Sheet #808ZB (FN #55)

Big Block Z-bar 67-76 A-body applications with Standard Trans (1-3/4" or 2" Headers)

Z-Bar P/N: ZB307

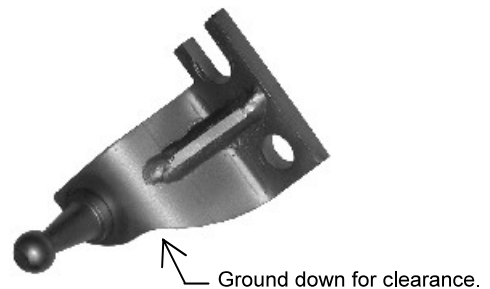
► Modification required to the "Stock" Z-bar for header clearance.
